August 22, 2011

**Re: Ameren Missouri  
Sioux Power Station  
Response to Dewberry & Davis Final Coal Combustion Waste Impoundments  
Round 7 – Dam Assessment Report**

RE: Ash Pond Stability Recommendations  
Sioux Power Station

Figure 1

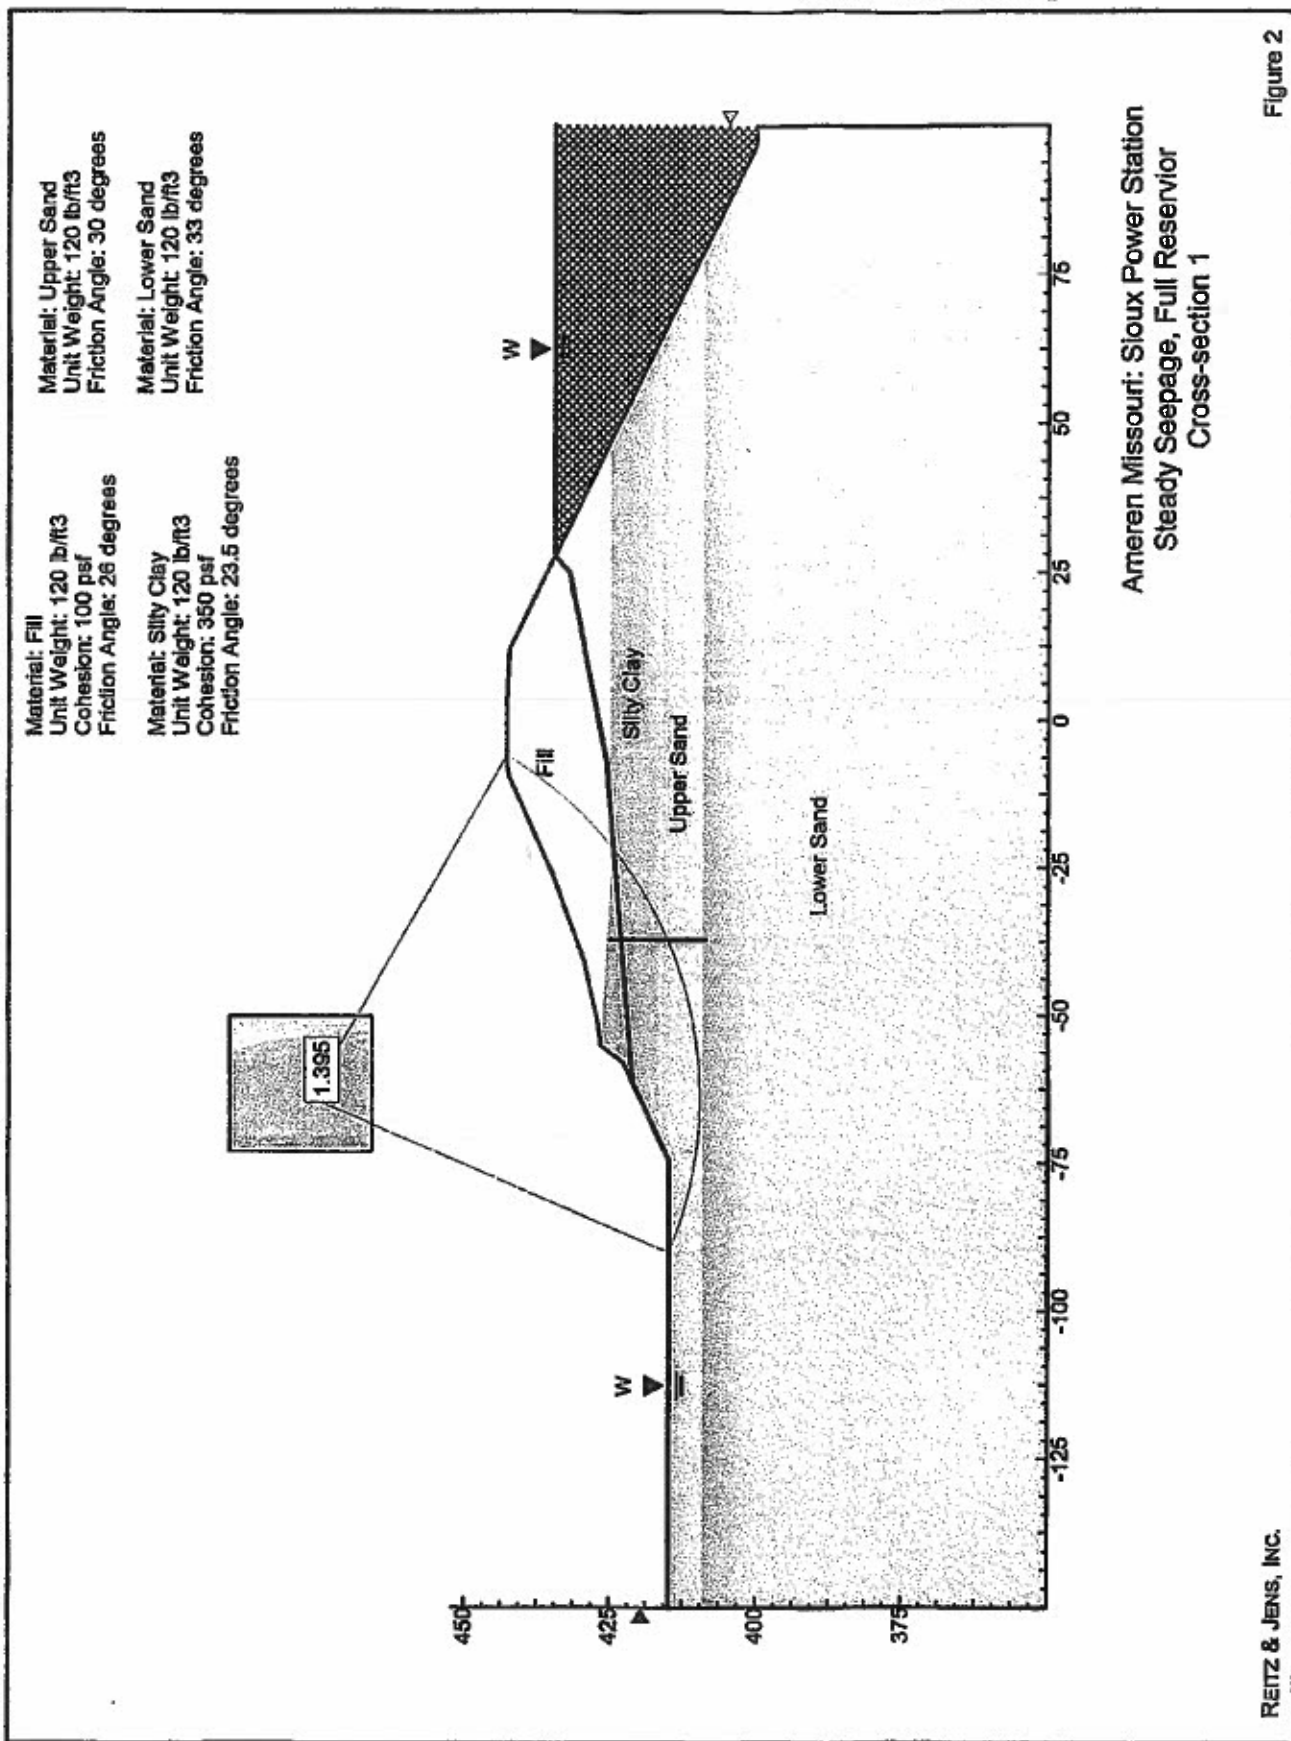
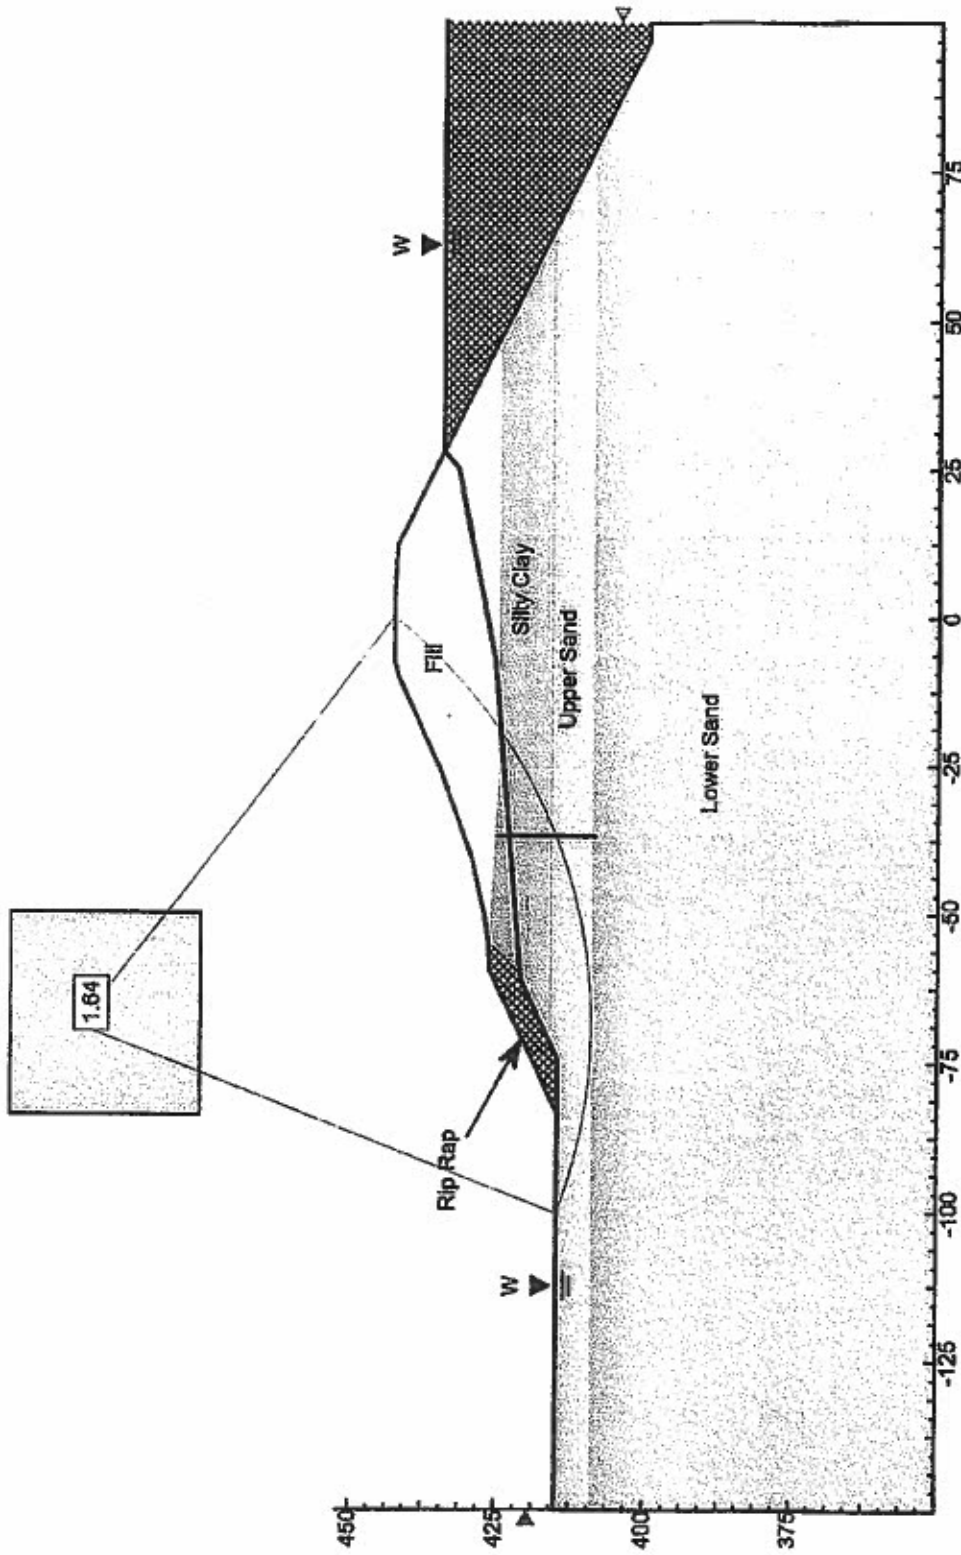
Reitz & Jens performed analyses of the Sioux Power Station ash pond embankments in November 2010, and found two areas of the Bottom Ash Pond which had factors of safety (FS) less than 1.5 for full pond (“reservoir”), steady-state seepage, and long-term (drained) shear strength properties. Ameren Missouri asked Reitz & Jens to re-analyze these areas and to provide recommendations for increasing the FS to 1.5 or greater for those areas where the FS is now less than 1.5.

For cross-section 1, we recommend constructing a rock wedge along the adjacent slope of the drainage channel slope to increase the FS to 1.5. The rock wedge should be a minimum of 3 feet thick and built to a maximum 2H:1V slope where the slopes of the drainage channel are higher or steeper than the drainage channel slope shown in cross-section 2. A 17-foot wide by 4-foot thick stability berm is recommended for the north cross-section to achieve a minimum FS of 1.5. The extent of these stabilization measures should be determined by a topographic survey of the area.

Figure 3

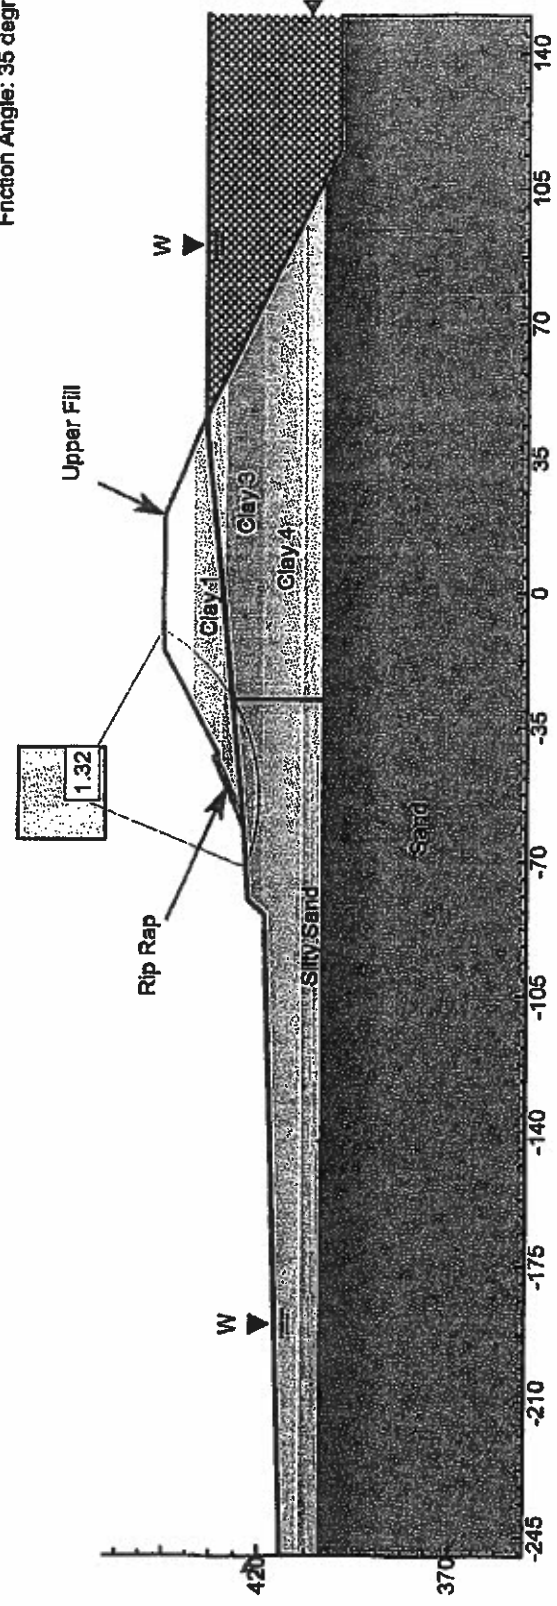
Cross-section	Factor of Safety	
	Existing Long-term	Improved Long-term
1 (Northwest)	1.40	1.64
North (Northeast)	1.32	1.52
2 (West)	1.51	N/A
